APPLICATION FOR DETAILED PLANNING CONSENT

Liam Russell Architects

JOB		CHECKED
THE FORMER WEST DRAUGHTON POLICE STATION ROAD WEST DRAUGHTON		LRA
CLIENT		DRAVNN
AREA ESTATES		MC
DATE		09/14
SCALE		1:100 @ A1 1:200 @ A3
DRAWING		REVISION
THE HOUSES: UNITS 32 & 38-41		A
INCLUSIVE ELEVATIONS & TYPICAL SECTIONS		NUMBER
		1105-PA-033

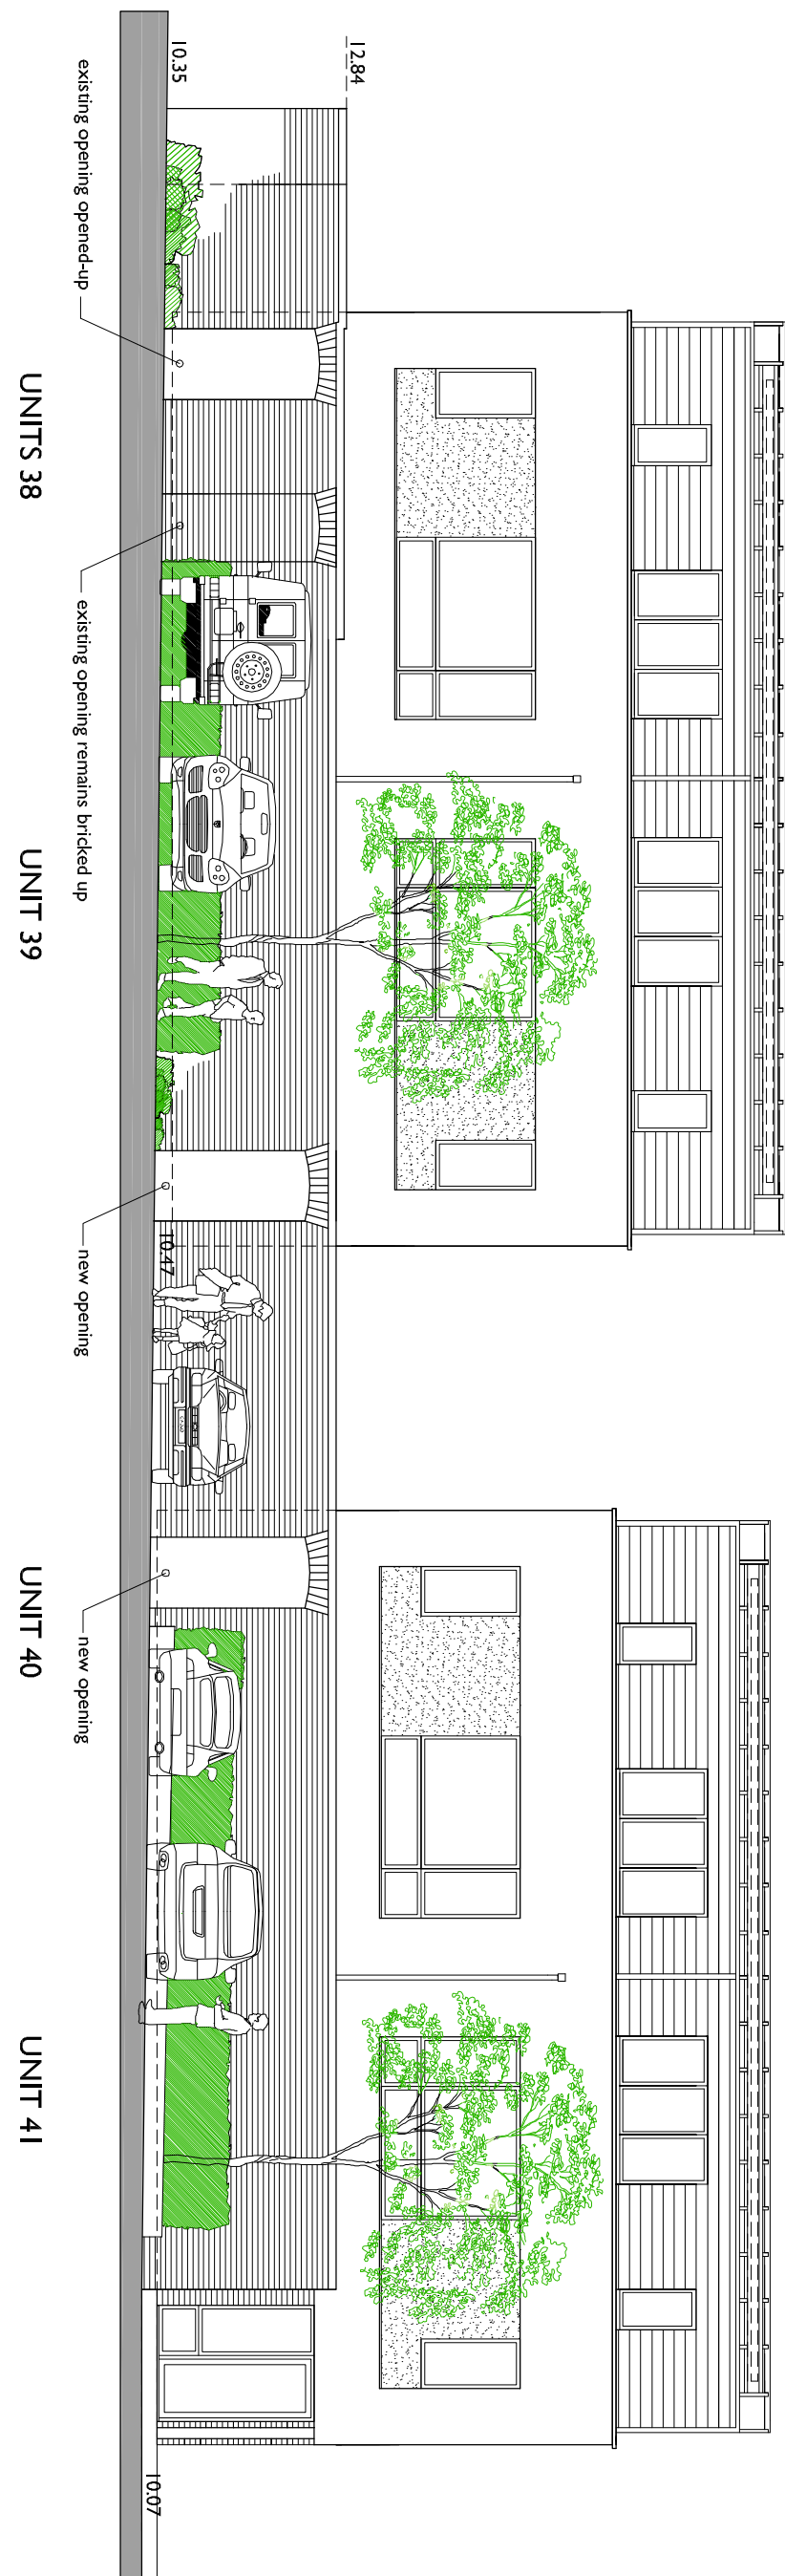
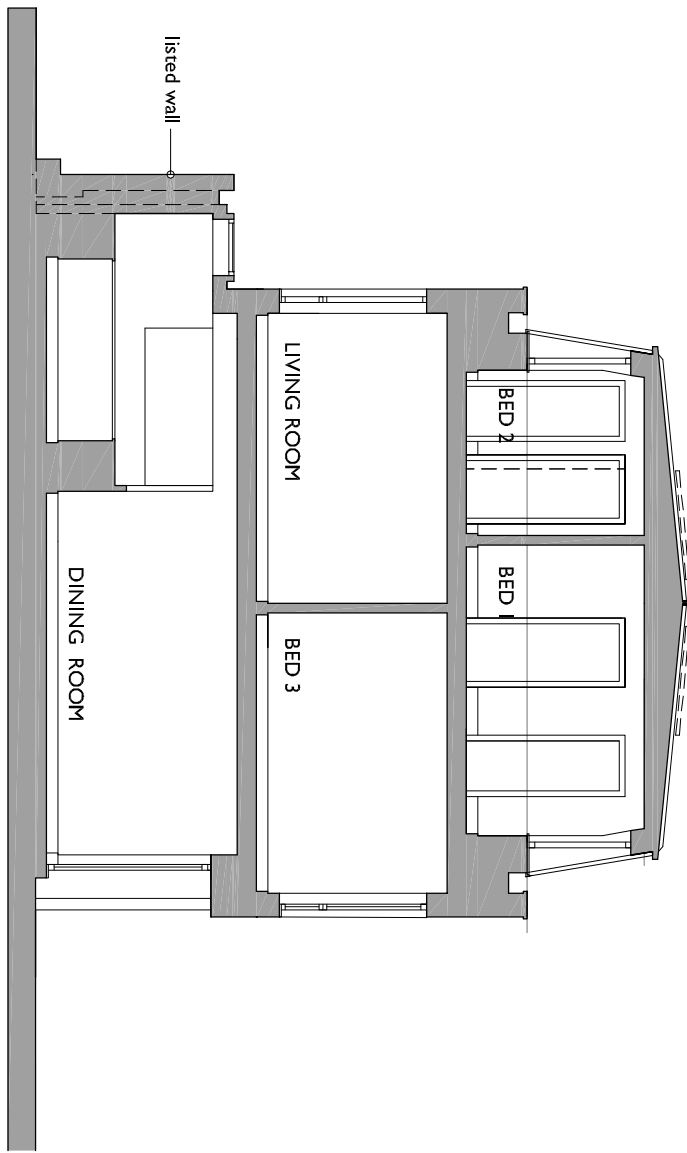
A 26/09/14 top floor reduced in height to 2350mm, curved profile replaced by angular profile, lead cladding replaced by zinc cladding, roof height reduced by 1100mm. Cable and vec back detail added in response to planners comments.

rooflight behind listed wall reduced in height in response to planners comments.
